# Appendix H - Existing Informal Passing Places and Proposed Improvement Locations

Reference plan showing existing & improved passing place locations

## Passing Place A (PP - A) shown on TPS Drawing 0110 P3 (Approx. Ch.140)

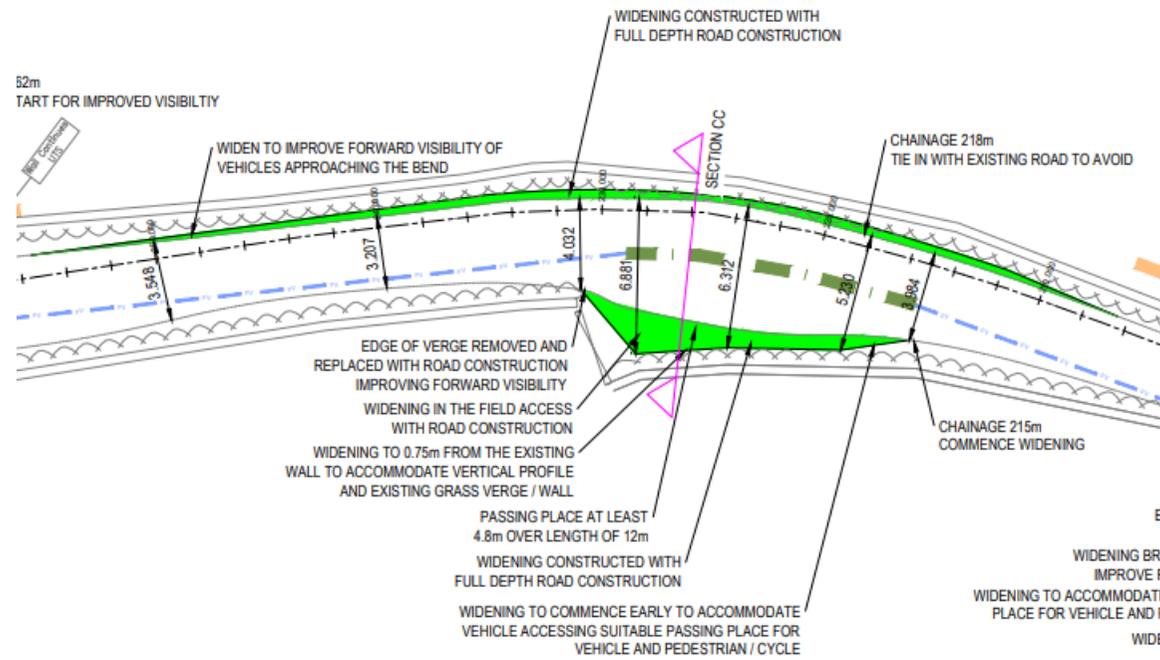
- There is already a passing place in this location, which is circa 10m long by 5.5m+ wide and can accommodate multiple cars. Therefore, the proposal effectively resurfaces the carriageway that already exists (or existed as it is currently eroded to sub-base level within the existing widening). As such, these works have only margin benefit by improving the existing carriageway surface.
- The improved carriageway surface may assist motor vehicle traffic, and potentially cyclists when passing. However, it may also increase traffic speeds, to the detriment of active travel users.
- The improvement to visibility noted on the plans is marginal (and has not been quantified).
- The suggestion to remove the bench is unacceptable.

## Passing Place C (PP - C) shown on TPS Drawing 0110 P3 (Approx. Ch. 230)

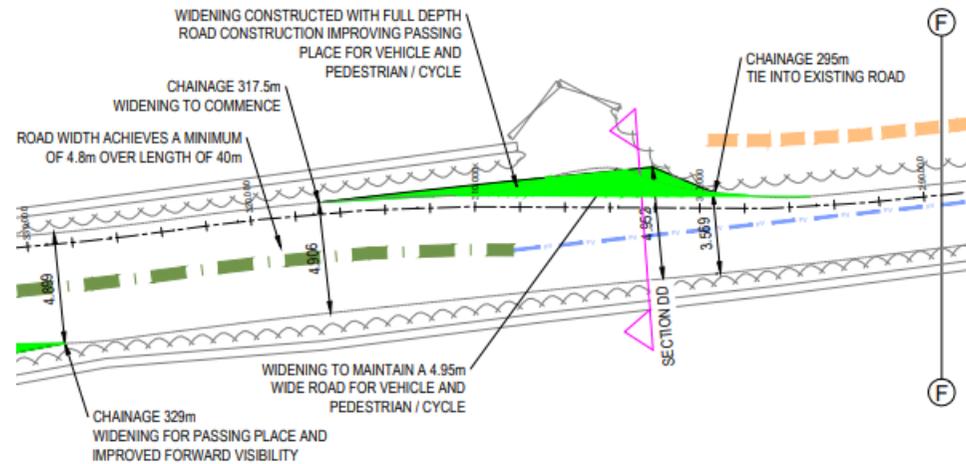
- There is already a passing place in this location. Whilst the proposal increases the width of the passing place slightly, this additional width may have limited benefit. This is due to there being sub-standard forward visibility from this passing place (looking northwest), so drivers are unlikely to utilise the extra width, as this will result in their visibility being further restricted.
- The new passing place design includes an abrupt exit taper (1:1). Therefore, it is unclear whether a vehicle could effectively exit the passing place, and utilise the extra space provided.
- No swept path analysis has been provided, to confirm whether the passing place is functional.
- The passing place does include some additional width, which could increase capacity (if the spaces is usable, which has not been demonstrated) for circa two cars to pass, so may have some minor benefit.

## Passing Place D (PP - D) shown on TPS Drawing 0110 P3 (Approx. Ch. 300)

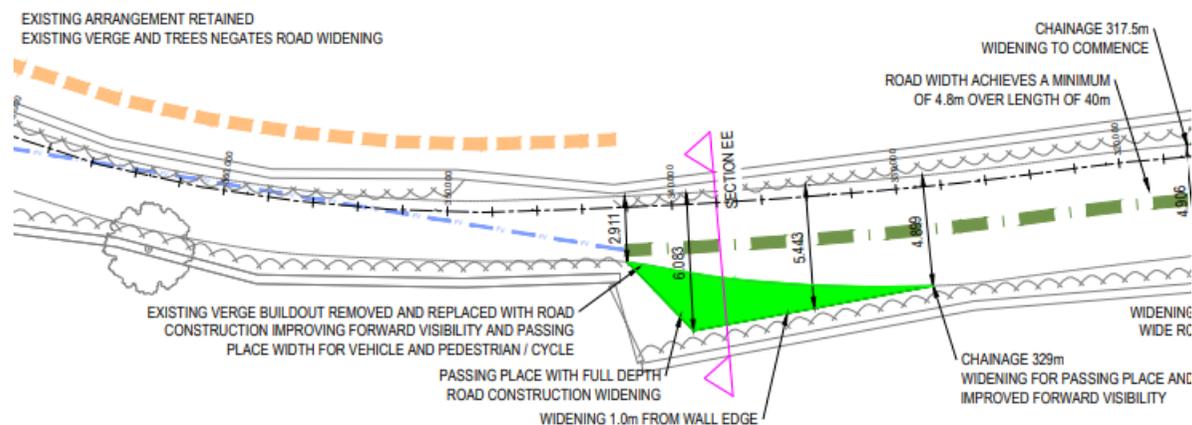
- There is already a passing place in this location. Whilst the proposal increases the width of the passing place slightly, this additional width is minimal and would have limited benefit. There is also sub-standard forward visibility from this passing place (looking southeast), so drivers are unlikely to utilise the extra width, as pulling further to the left will result in their visibility being further restricted.
- No swept path analysis has been provided, to confirm whether the passing place is functional. However, the exit taper at this passing place is better than some of the other proposed designs, so may function adequately (but this has not been demonstrated).
- The passing place includes only minimal (if any) additional width, and the carriageway is already a reasonable width in this location (e.g. 4.8m+). Therefore, any benefit from these works is minimal.

## Passing Place E (PP - E) shown on TPS Drawing 0110 P3 (Approx. Ch. 340)

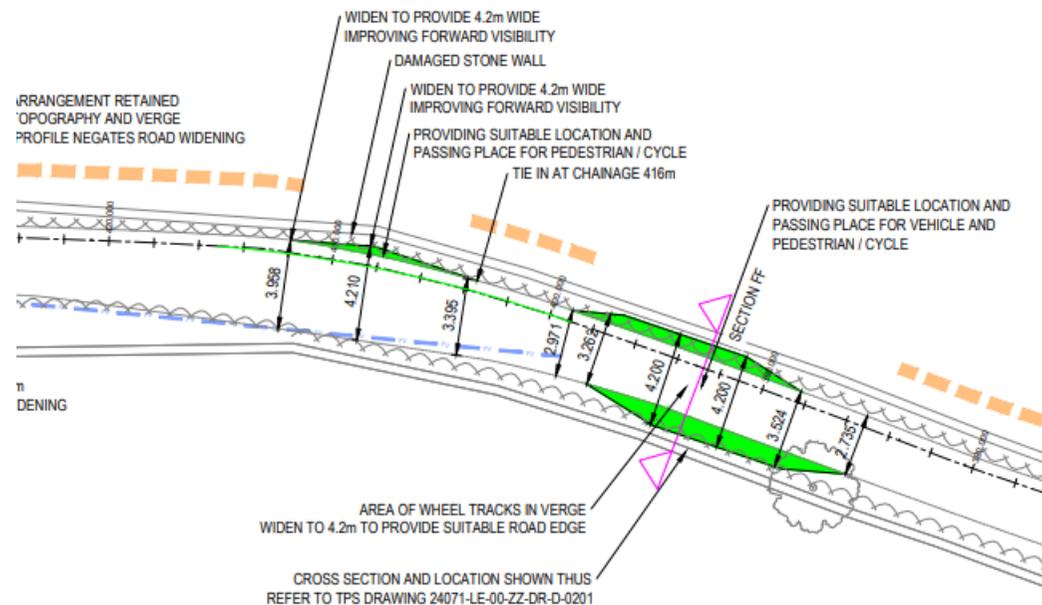
- There is already an informal passing place adjacent to the field gate in this location. Whilst the proposal increases the width of the passing place slightly, and provides a hard paved surface that would be of benefit to motor vehicles and cyclists, no additional highway width is created. Therefore, there will be no material improvement in capacity of the existing informal passing place.

- The new passing place design includes an abrupt exit taper (1:1). Therefore, it is unclear whether a vehicle could effectively exit the passing place, and utilise the extra space provided. This is unlikely, given the narrow carriageway (2.9m) immediately northwest of the passing place.

- No swept path analysis has been provided, to confirm whether the passing place is functional.
- The extended passing place is unlikely to be deliverable as shown, as the exit taper impacts on a boundary wall (that has been damaged by existing vehicle overrun, but not shown on the plans) adjacent to the field entrance. It is noted that boundary walls do not typically form part of the highway, so it is unlikely that the wall could be removed and the additional land dedicated as highway to provide the extended passing place (even if it were demonstrated to be functional, which does not appear to be the case).

- There is severely restricted forward visibility looking northwest from this passing place, which is not improved in any way by these proposals. The visibility is restricted due to vegetation on the inside of the right hand bend to the northeast, which cannot be significantly improved, as there are trees that block visibility that are generally beyond or straddle the highway boundary. This includes a large oak tree (not shown on the Appellants drawings, as is the case for many trees that are missing from the drawings), which would need to be removed to increase visibility to acceptable levels. However, the removal of the oak tree is unlikely to be acceptable (and has not been identified or assessed).

## Passing Place F (PP - F) shown on TPS Drawing 0110 P3 (Approx. Ch. 390)

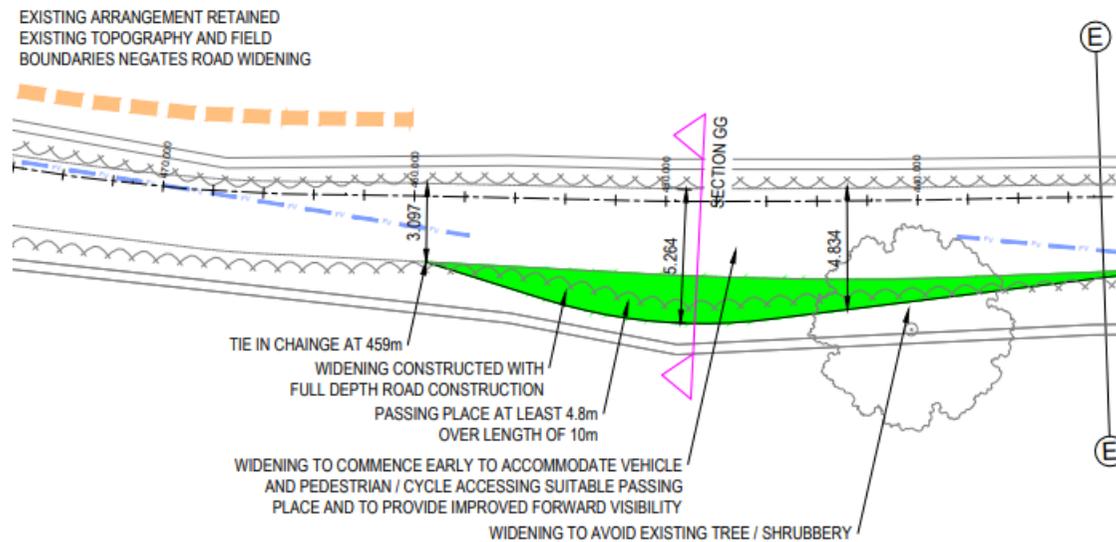
- Small vehicles already pass in this informal passing place, by overrunning the adjacent highway verges. However, the width of the highway in this area is inadequate to allow two cars to safely pass (e.g.  $4.8\text{m} + 2 \times 0.5\text{m}$  offsets from walls =  $5.8\text{m}$  total highway width required). Therefore, the  $4.2\text{m}$  wide formalised passing place that is proposed would be ineffective, and provide little if any improvement over the current situation, with this passing place being well below standard.

- The proposed carriageway widening is also staggered due to existing trees growing within the adjacent verges and walls (that are not shown on the plans). This results in the effective length of the passing place being circa  $3\text{m}$ , which could not accommodate a vehicle.

- No swept path analysis has been provided, to confirm whether the passing place is functional, although it is quite clear that this would demonstrate that it is not.

- The passing place is shown built up to boundary walls, which will not provide safe clearance for drivers. However, this is more of concern for cyclists, who require a minimum of  $0.5\text{m}$  clearance to avoid clashes with their pedals and handlebars. Therefore, this formalised passing place would not benefit cyclists.

- It is unclear how this widening would be undertaken. However, it appears that it would require upgrade of the boundary walls, which has not been identified on the plans. This is likely to require works that are beyond the highway boundary, so it is unclear whether the proposal is deliverable.

## Passing Place G (PP - G) shown on TPS Drawing 0111 P3 (Approx. Ch. 450)

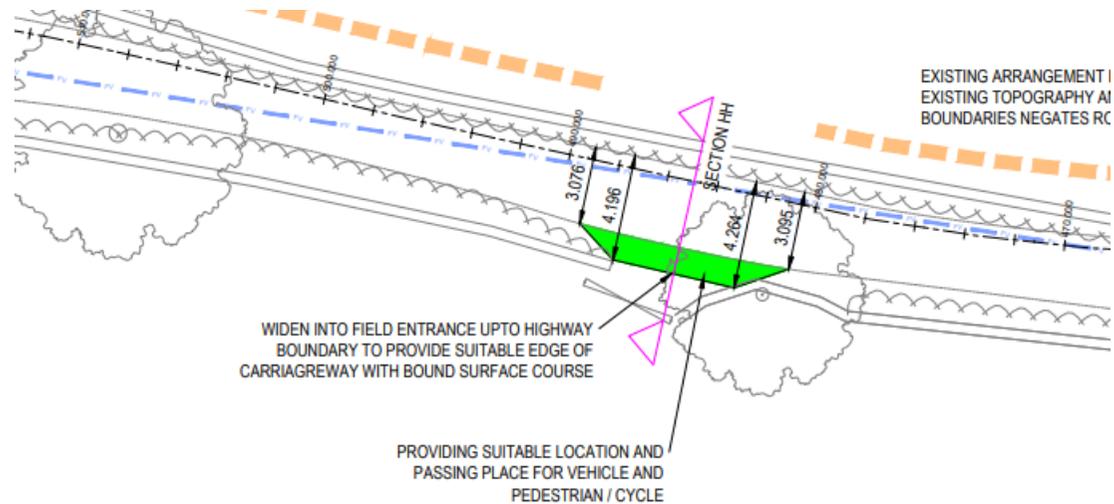
- This location is already used as an informal passing place. Therefore, the proposal provides only marginal benefit, by hard paving the informal passing place that already exists (and is currently longer than is shown for the improved passing place).
- The carriageway widening that has been shown, is likely to impact the existing vegetation along the west side, which includes trees (most of which are not shown on the plans) along the highway boundary. The base of these trees are higher than the existing carriageway level. Therefore, cutting into the base of the trees and verge in this location, is likely to damage them and result in their loss. Therefore, it is unlikely that widening will be possible to the extent shown.

## Passing Place H (PP - H) shown on TPS Drawing 0111 P3 (Approx. Ch. 490)

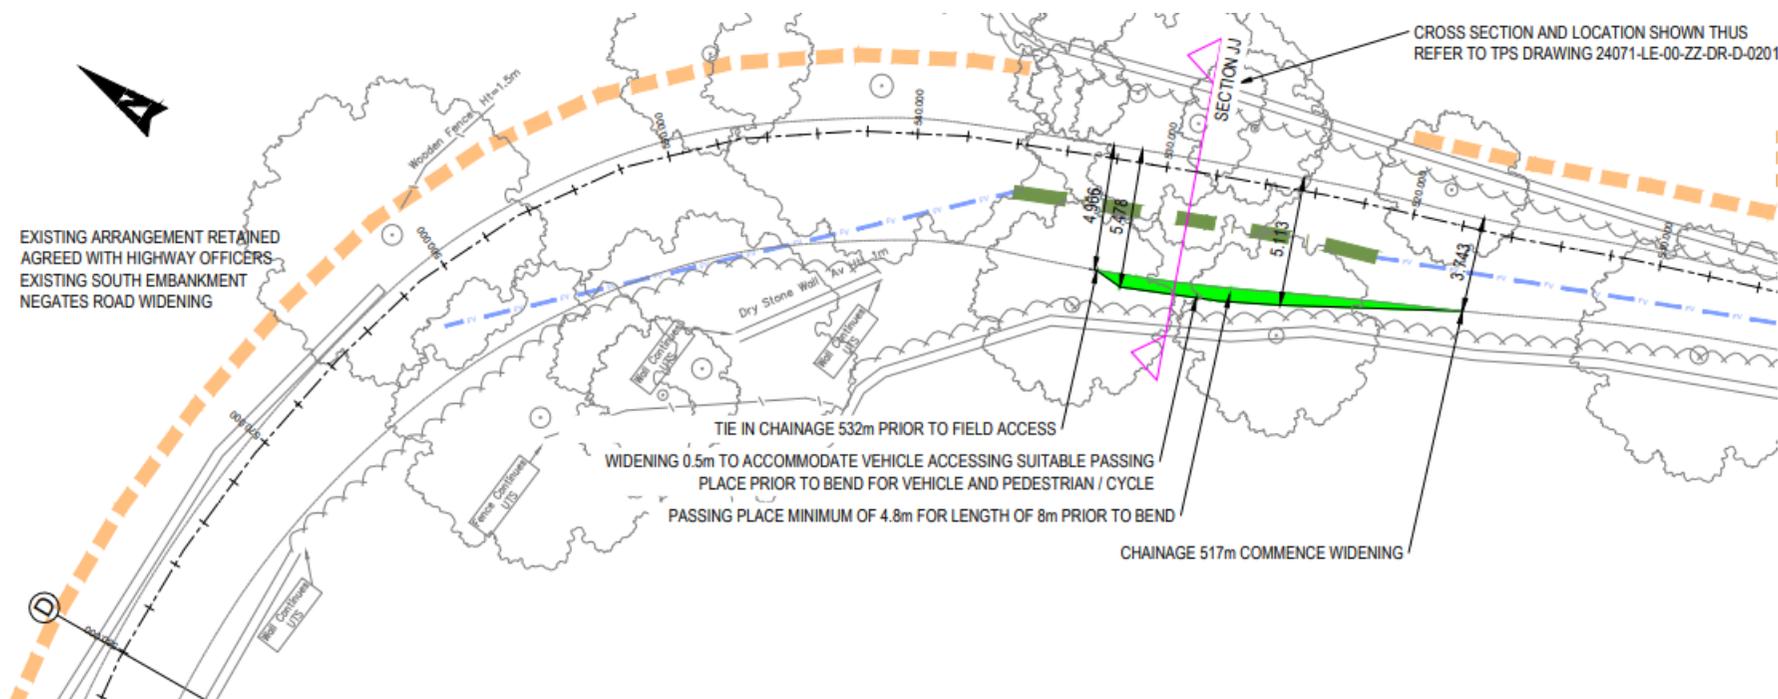
- Small vehicles already pass in this location, by overrunning the adjacent highway verges. However, the width of the highway in this area is inadequate to allow two cars to safely pass (e.g.  $4.8\text{m} + 2 \times 0.5\text{m}$  offsets from walls =  $5.8\text{m}$  highway width required). Therefore, the  $4.2\text{m}$  wide formalised passing place proposed would be ineffective, and provides little if any improvement over the current situation, with this passing place being well below standard.

- No swept path analysis has been provided, to confirm whether the passing place is functional. However, the short tapers, short length of the passing place ( $5\text{m}$ ) and narrow width, will not allow it to operate safely (e.g. it doesn't work adequately now, and the improvements suggested offer little, if any, benefit).

- The passing place is shown built up to the boundary wall, which will not provide safe clearance for drivers and cyclists.
